Open issues on the 1000m link specification Draft 0.3

Dieter Schicketanz consultant
Reutlingen University
Masood Sharif Commscope

Return loss 146.7.1.3s

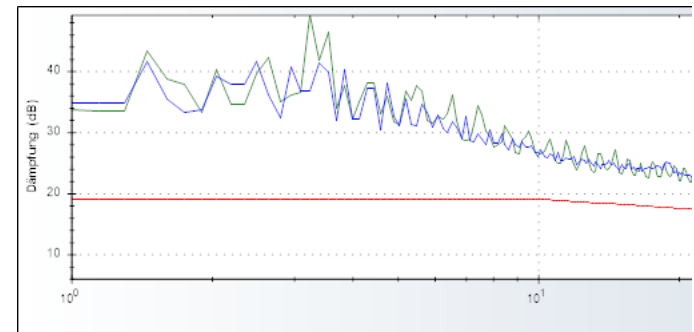
Return loss was presented first time mid 2016 by Fritsche Schicketanz

At the meantime measurements were done and most show that at 20 MHz the limit does not follow measurements (450m AWG18 cable 6m cord).

It is therefore proposed to relax the RI values at 20 MHz. It would match also most other IEEE links and cabling channels.

Add to equation 146-3

- $10 < f \leq 20$ MHz
- $RI(f) = 24 - 5\log(f)$
